APPLICATION NO.	FILING DATE	FIRST NAMED INVENTOR	ATTORNEY DOCKET NO.	CONFIRMATION NO.
10/598,343	08/24/2006	Marc Peuker	59606US007	2805
	7590 09/23/201 IVE PROPERTIES CO	EXAMINER		
PO BOX 33427		ROSEN, ERIC J		
ST. PAUL, MN 55133-3427			ART UNIT	PAPER NUMBER
			3732	
			NOTIFICATION DATE	DELIVERY MODE
			09/23/2011	ELECTRONIC

Application No.	Applicant(s)				
Office Action Occurrence	10/598,343	PEUKER ET AL.				
Office Action Summary	Examiner	Art Unit				
	ERIC ROSEN	3732				
The MAILING DATE of this communication appo Period for Reply	ears on the cover sheet with the c	orrespondence ad	dress			
A SHORTENED STATUTORY PERIOD FOR REPLY WHICHEVER IS LONGER, FROM THE MAILING DA - Extensions of time may be available under the provisions of 37 CFR 1.13 after SIX (6) MONTHS from the mailing date of this communication. - If NO period for reply is specified above, the maximum statutory period with Failure to reply within the set or extended period for reply will, by statute, Any reply received by the Office later than three months after the mailing earned patent term adjustment. See 37 CFR 1.704(b).	TE OF THIS COMMUNICATION 6(a). In no event, however, may a reply be tim ill apply and will e

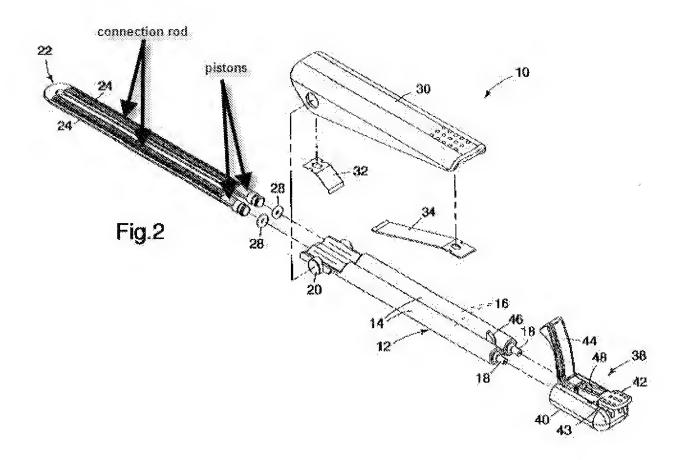
- 26. Claims 20, 25, 27, 31, 33 and 35 are rejected under 35 U.S.C. 103(a) as being unpatentable over Broyles and in view of Dark (US 6616012 B2).
- 27. Regarding claims 20, 33 and 35, Broyles discloses a delivery system 10/38 (figure 2) and 60 (figure 6) for controlled dispensing of a substance, the system

comprising: a cartridge 12/22 having at least two compartments for storing material components to form a substance; a plunger 22 having at least two pistons (see "pistons" in figure 2 below) for sealing the respective compartments and advancing the material components in the at least two compartments; and a lever 30 and a geared connection rod (see "connection rod" in figure 2 below) for providing controlled dispensing of the substance, wherein the lever is integrally formed with at least a part of the cartridge (see figure 2; the lever 30 is integrally formed with element 20 of the cartridge during assembly), and wherein the geared connection rod (see "connection rod" in figure 2 below) is integrally formed with the plunger 22. Re. claim 27, Broyles further discloses a reservoir 60 (figure 6) for receiving the mixed substance). Re. claim 31, Broyles further discloses the cartridge comprises an actuator part 22 (element 20 also serves as an actuator part; figure 2) and a material receptacle 12 having at least two compartments 14 for storing material components, the material receptacle being separable from the actuator part (element 22 is shown to be separable in figure 2). Re. claim 33, Broyles further discloses a substance for the treatment of caries (Col. 1, lines 45-46).
